ISSUE: Certificate of Appropriateness for alterations

APPLICANT: American Group Medical Association

LOCATION: Old and Historic Alexandria District
1 Prince Street

PROPOSED PLAZA IMPROVEMENTS & WINDOW REPLACEMENT PROJECT

PHOTO 1 - EXISTING WINDOW - SINGLE FIXED UNIT WITH BRONZE ANODIZED FRAME AND TINTED GLASS

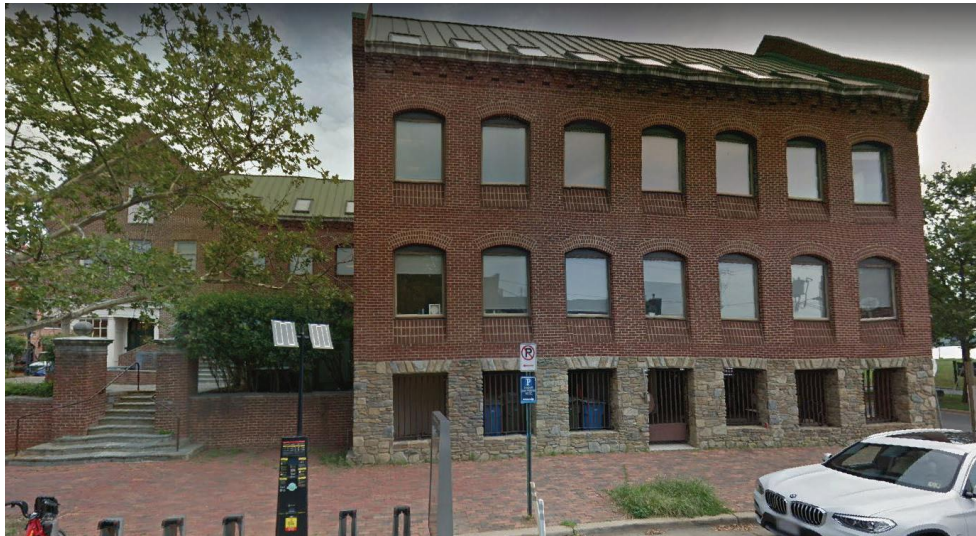
However, staff does not support the bronze tint and slight reflectivity of the proposed windows because it does not comply with the BAR's adopted policy that glazing on all windows should be clear, non-reflective and without tint. Low-E glazing is encouraged for energy conservation, but the glass must have a minimum 72% visible light transmission, Low-E 272 generally meets the criteria.

1. Submit window specifications prior to applying for building permit to confirm compliance with the BAR's adopted window policy;
2. The maximum height of all mechanical screening must not exceed six feet;
3. Confirm the intensity of the exterior lighting is appropriate for the site and is not the brightest lighting on the block-face; and,
4. As noted in the zoning comments in Section IV, the applicant must confirm whether a Minor Site Plan amendment is required prior to issuance of a building permit.

A ELEVATION - Green Screen at Fountain and Utility Yard
Scale: 1/4" = 1'-0"

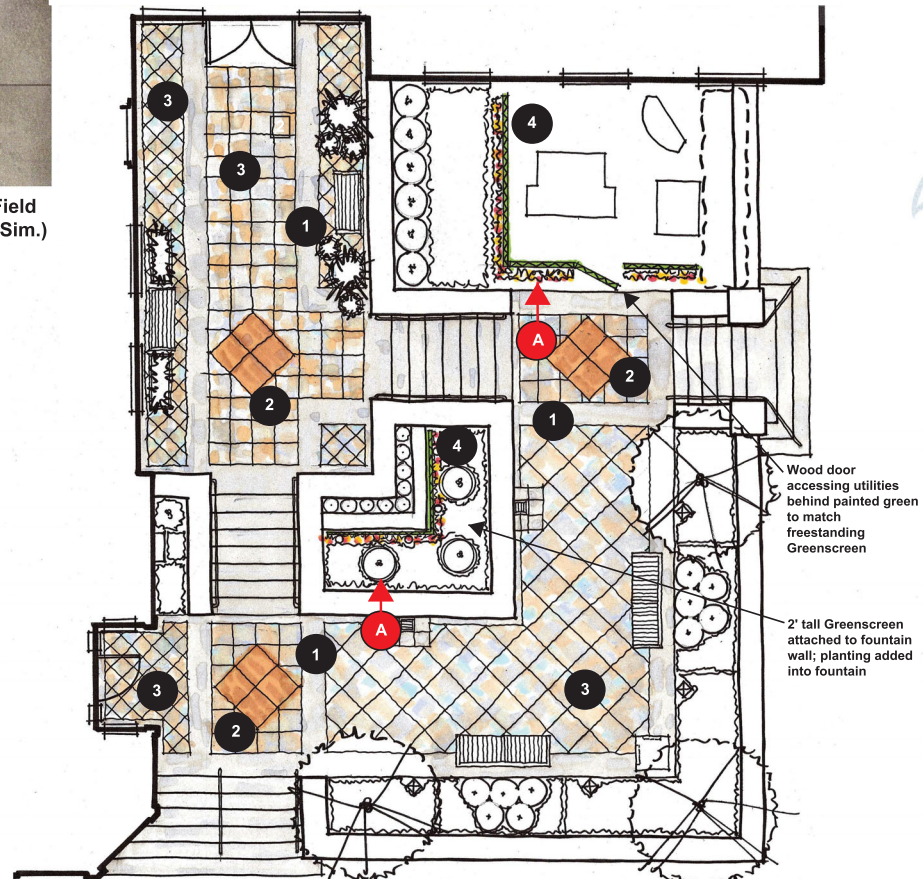
The applicant is proposing to screen the existing utility yard in the elevated plaza with a freestanding Greenscreen with vines and an access wood door. A Greenscreen is the trade name of a brand of open or woven metal installed as a vertical trellis/fence intended to support plant material. The existing utility equipment is visible from the public right-of-way and the *Design Guidelines* state that utilities located in a visually prominent area of a building should be screened. Staff supports the proposed screening, however, the proposed 8' Greenscreen on the north elevation of the utility yard is visually unsupported and unrelated to the height of surrounding fences and masonry piers. Staff believes this one segment of Greenscreen should be reduced to 6' to match the screening on the west elevation. Six feet of Greenscreen will sufficiently screen the utility yard.

BOLLARD - Product Data Sheet

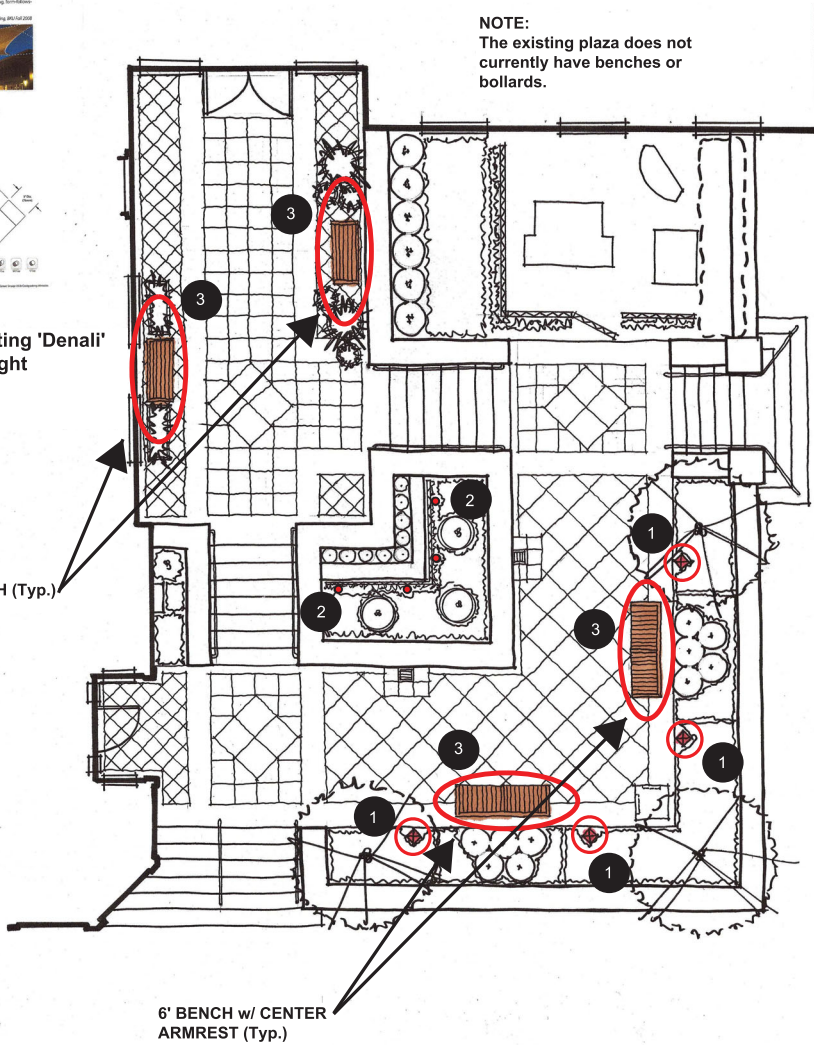
The proposed bollard lighting will be 38" inches high and approximately 6" in diameter. The bollards will be located on the west and south elevation of the plaza. The uplights will be located in the proposed planter feature. The *Design Guidelines* state that the Board is primarily concerned with the intensity of the light and discourages lighting which detracts from the appearance of the historic district. The proposed lighting will accentuate the landscape elements of the plaza and provide illumination for safety reasons after dark. Staff supports the proposed exterior lighting. The applicant should work with staff to confirm the intensity of the exterior lighting, so that it is not the brightest feature in the area and does not overwhelm the nearby historic buildings.
